SUBJECT: NC 68/US 220 Connector from NC 68 at SR 2133 to the  
existing intersection of NC 68 and US 220 in Guilford and  
Rockingham Counties; WBS No. 34429.1.1  
**TIP R-2413A**

Also reference your letter to the Corps dated September 25, 2014 (received October 6, 2014), requesting modification of the permit for a net decrease in permanent impacts to streams and a net increase of temporary impacts to streams, for revisions to Sites 1, 2, 3, 4, and 22.

Subject: Modification to the 401 Water Quality Certification Pursuant to Section 401 of the Federal Clean Water Act and Jordan Lake Buffer Rules for the proposed new facility from SR 2011 to the Haw River at US 220 Guilford County; WBS No. 34429.1.1; TIP No. R-2413A; NCDWR Project No. 20130517 version 3.

## R-2413A Permit Drawing Update Summary

Date: 9/22/2014  
Des By: THS

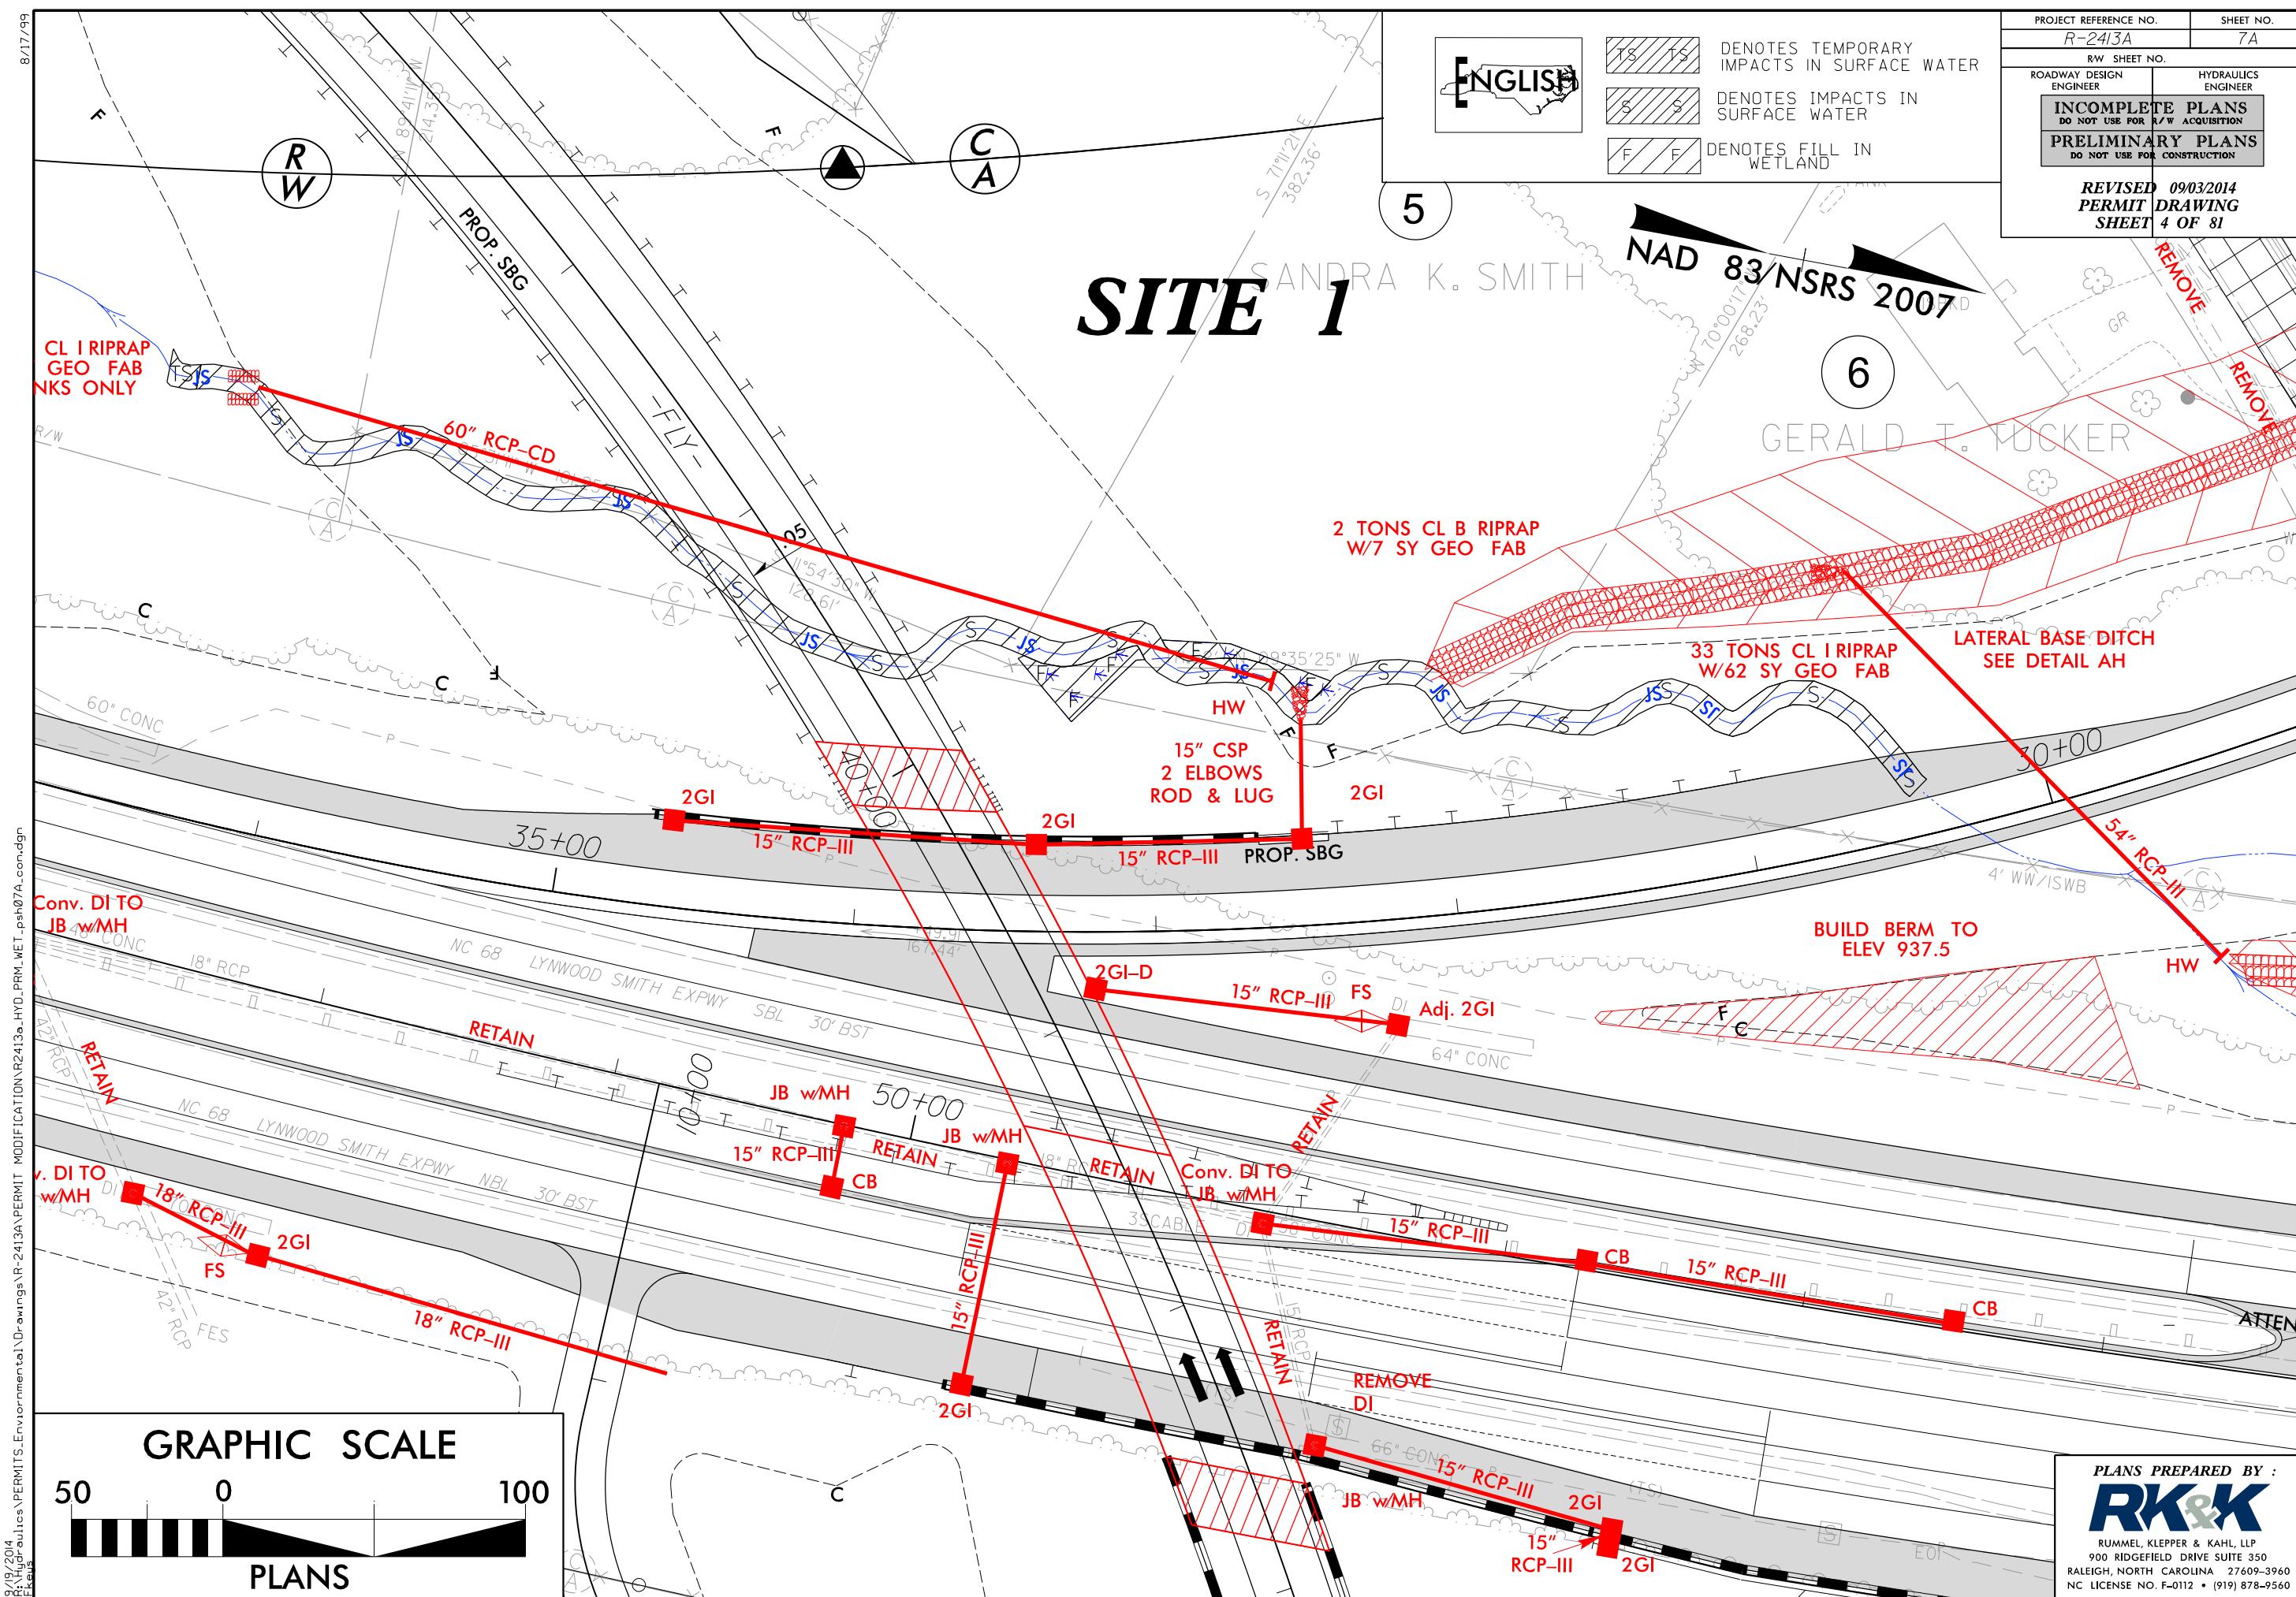
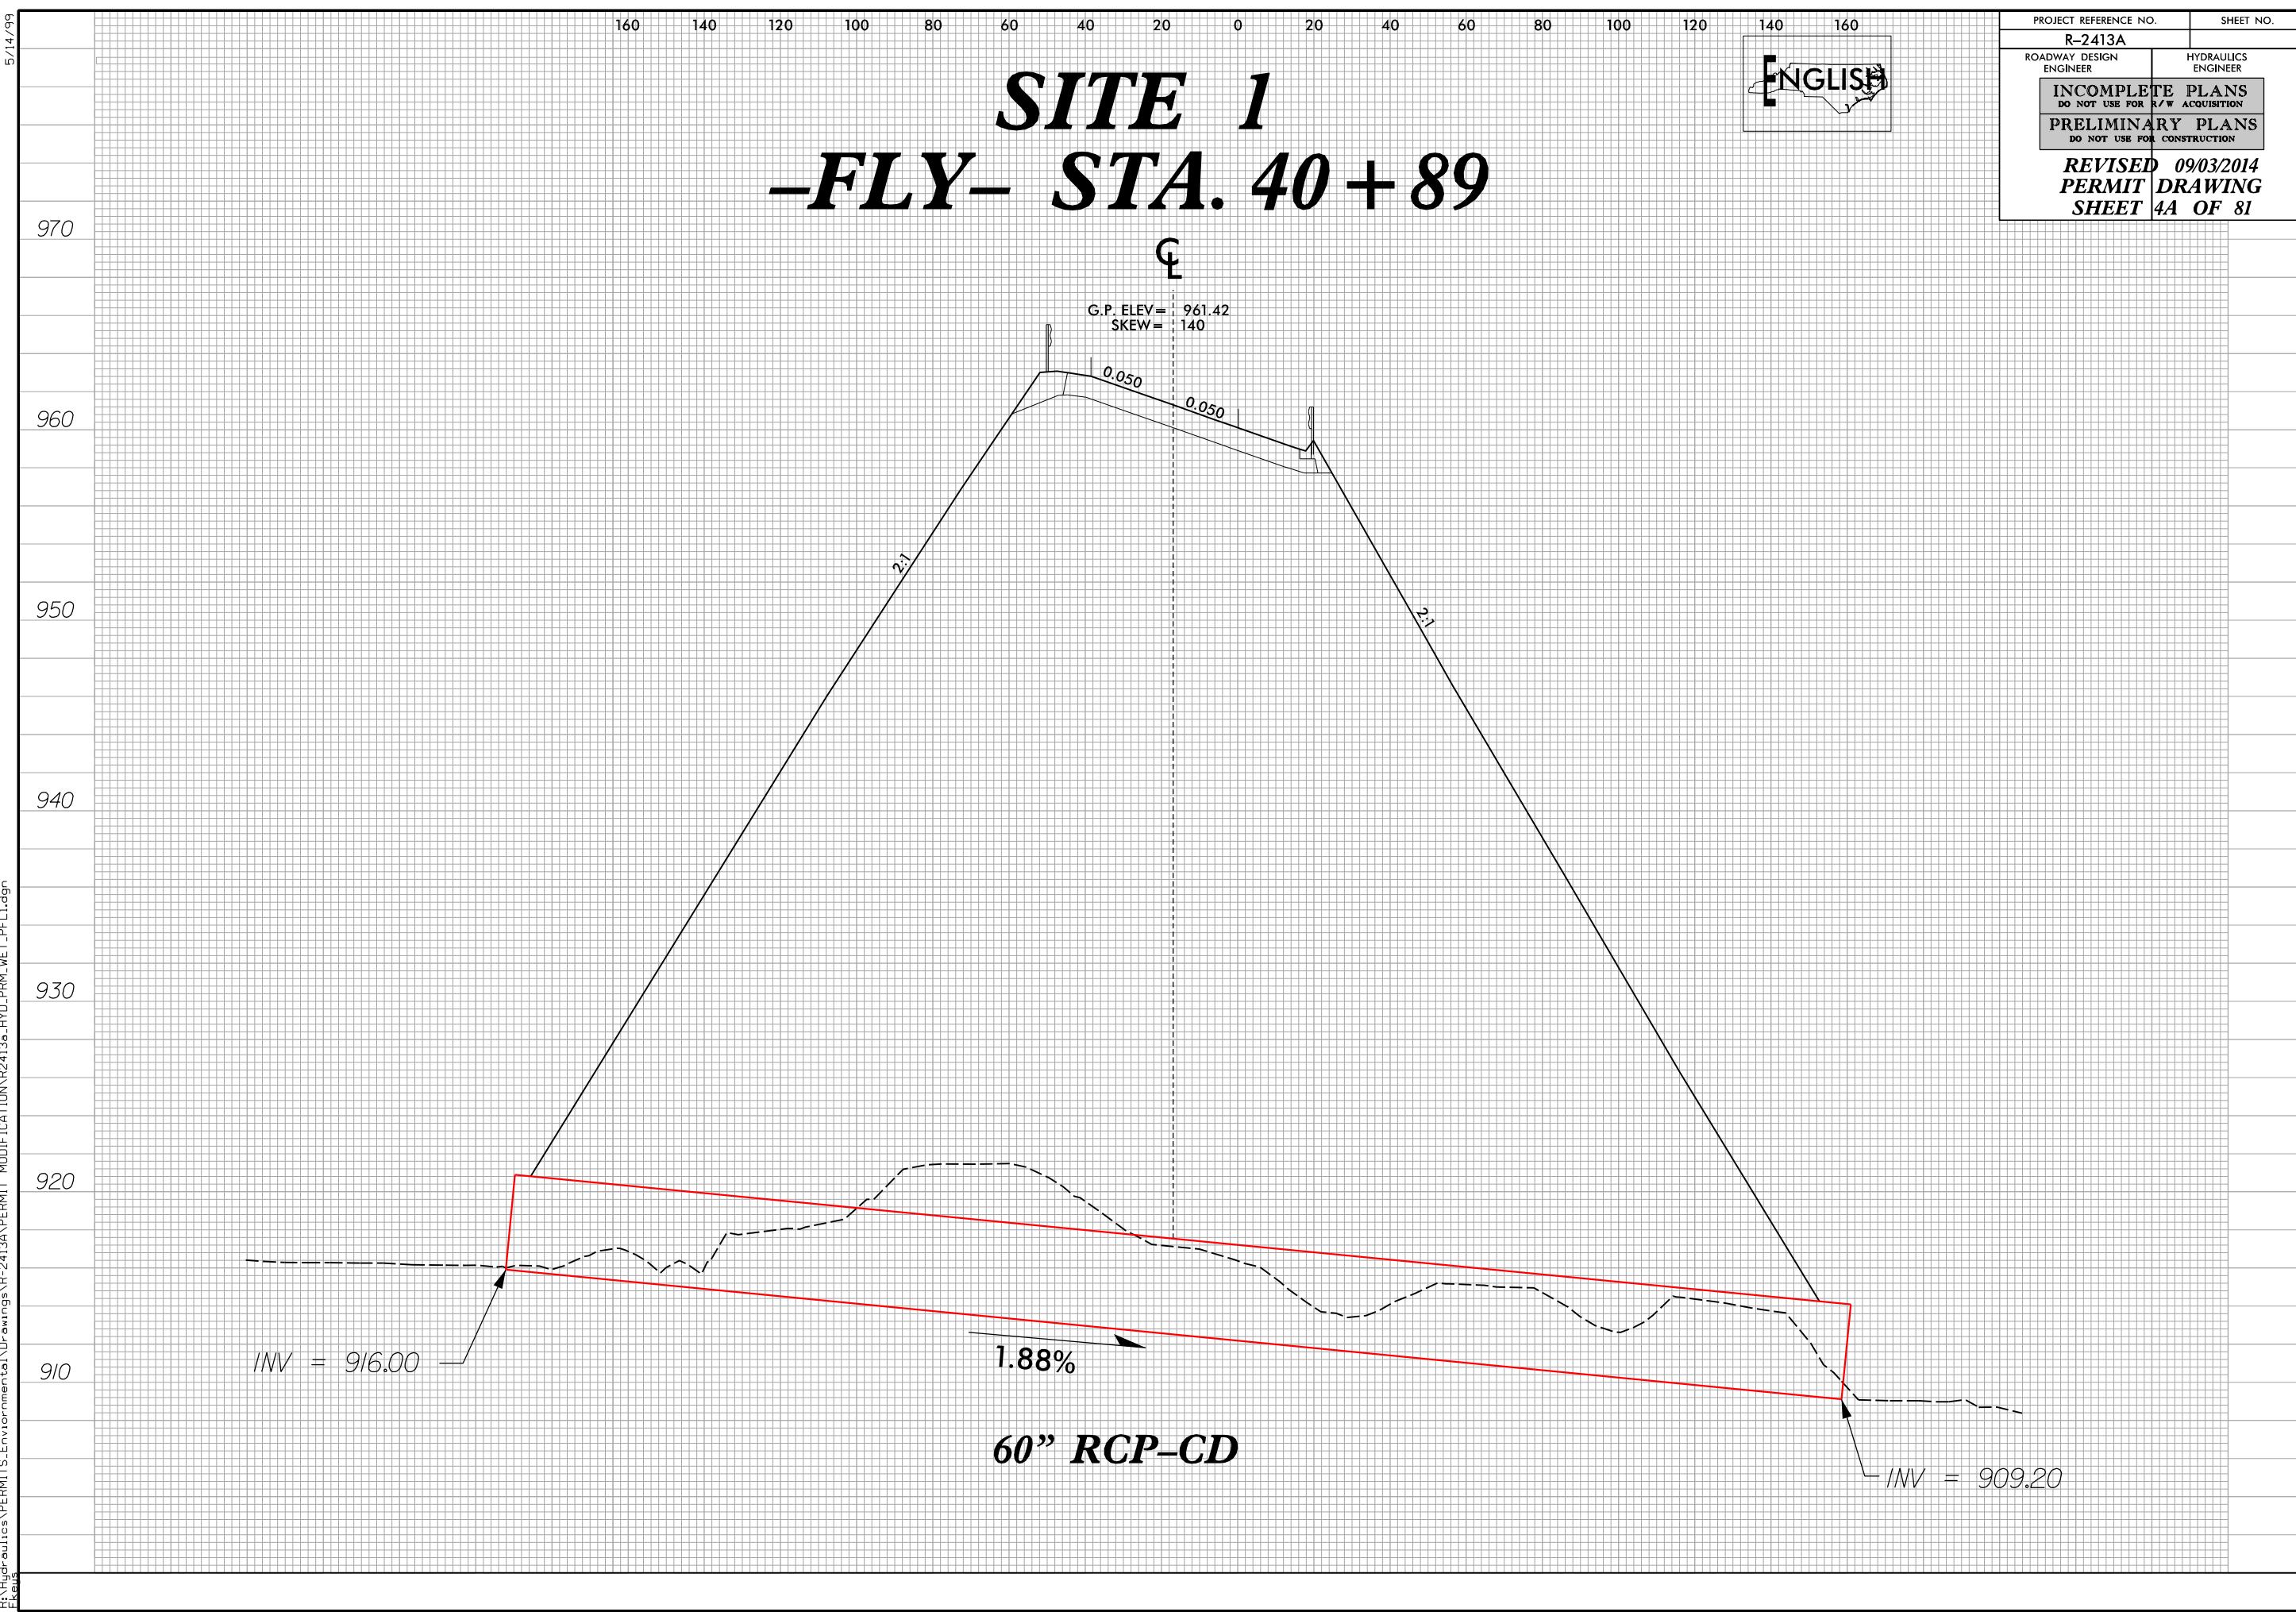
Permit Drawings	Plansheets	Site No.	Comments
1 of 81	1	N/A	Cover sheet Added Site 23 (left off original cover), adjusted location circles to be more accurate , includes current prepared by names etc
2-4 of 81	7	1	Permit Modification
4A of 81	Pipe Profile	1	Permit Modification
5 of 81	X Section	1	Original
6-7, 9-10 of 81	8,37	2,3	Permit Modification
8 of 81	Pipe Profile	2C	Original
11-13 of 81	9	4,5	Permit Modification
14 of 81	X Section	4	Original
15 of 81	9	5	Revised Minor system realignment from 0955-0953; Cross pipe 1801 changed from 66" to 60"
16 of 81	Pipe Profile	5	Original
17-19 of 81	12	6	Revised 1113-1115 changed from 2-54" to 48"
20 of 81	Pipe Profile	6	Original
21-23 of 81	13	7	Revised Minor system realignment from 1212-1213, 24" to 18", 54" to 48"
24 of 81	Pipe Profile	7A	Original
25-27, 29-31 of 81	14	8/9	Revised Minor system realignment from 1412-1414
28 of 81	Pipe Profile	8B	Original
29-30, 32-34 of 81	15, 16	9/10	Revised Minor system realignment from 1507-1508

32-34 of 81	16	10/11	Revised Minor system realignment from 1601-1602
35-36 of 81	Pipe Profile/X Section	10	Original
37-39 of 81	17	12	Revised system and ditches
40 of 81	Pipe Profile	12	Original
41-43 of 81	18	13	Revised Minor system realignment from 1801-1802; Cross pipe 1801 changed from 54" RCP to 60" RCP
44-46 of 81	20	14	Revised Cross pipe 2006 changed from 78" CSP to 72" CSP
47 of 81	Pipe Profile	14	Original
48-50 of 81	21	15,16	Revised undetectable system realignment from 2108-2111, 2113-2115, additional toe protection
51-52 of 81	Pipe Profile/X Section	16	Original
53-55 of 81	22	17,18	Revised Minor system realignment from 2208-2212, 2212-2215 pipe gauge changed
56-58 of 81	Bridge Profile/X Section	18	Original
59-61 of 81	23	19	Revised Minor system realignment from 2310-2311
62 of 81	Pipe Profile	19	Original
63-65 of 81	31	20	Revised Minor system realignment from 3101-3102
66 of 81	X Section	20	Original

66A-66C of 81	33	23	Revised Cross pipe 3305 changed from 30" CSP to 36" CSP
67-69 of 81	34	21	Revised undetectable system realignment from 3409-3410, additional toe protection and ditches
70-71 of 81	Pipe Profile/X Section	21A	Original
72-74 of 81	37	3,4	Permit Modification
75 of 81	X Section	4	Original
76 of 81	37	22	Permit Modification
77 of 81	Sill Detail	22	Original
78 of 81	Permit Impact Summary		Permit Modification
79-80 of 81	Permit Impact Summary		Original
81 of 81	Permit Impact Summary		Permit Modification
